STORMWATER MANAGEMENT REPORT ADDENDUM – 03/04/16

Proposed Site Plan – 50 Duchaine Boulevard (Assessors Map 134, Lots 456, 457, 458, and 459) New Bedford, Massachusetts

Purpose

SHEET 3 OF 7

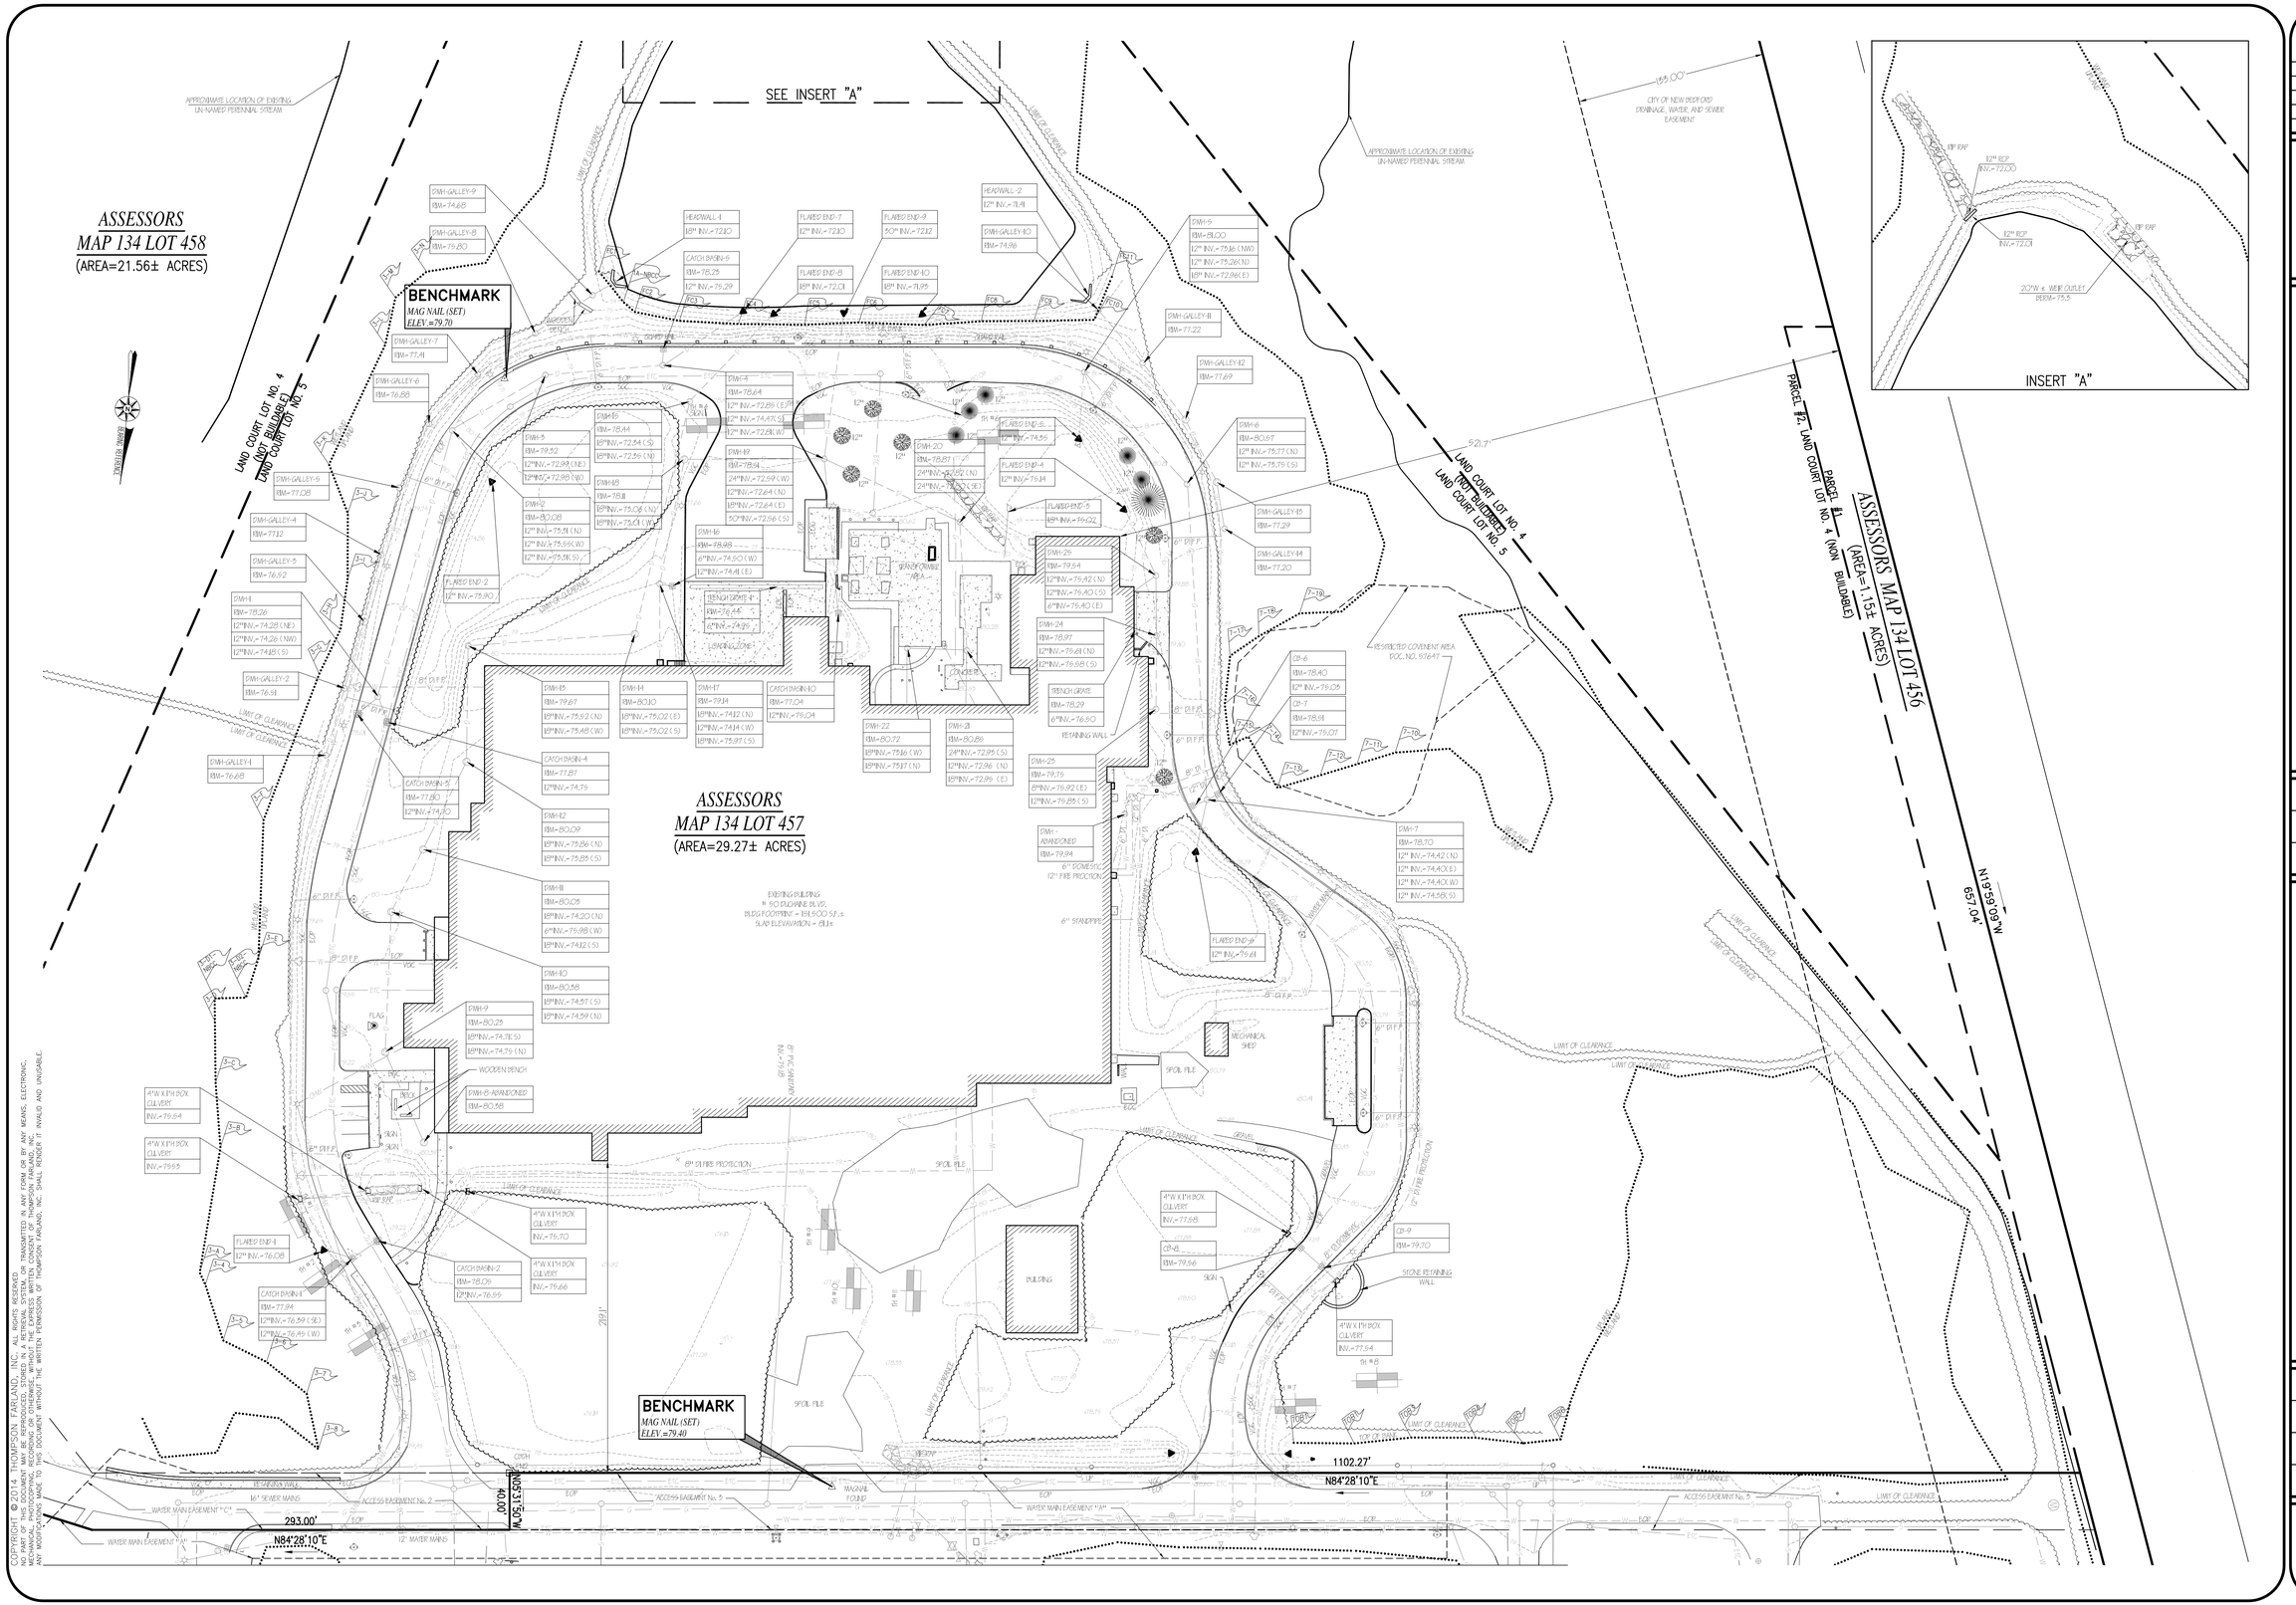
The purpose of this addendum is to provide revised Pipe Capacity Calculations as requested by the Nitsch Engineering in a peer review letter dated March 1, 2016. Also included herein are revised Existing Conditions Plan (Sheet 3 of 7) and revised Grading and Utility Plan (Sheet 5 of 7), which have been revised to provide structure labels consistent with the pipe capacity calculations. These calculations will replace those calculations found in Exhibit “O” of the previous report. All other previous drainage calculations and report appendices remain valid.
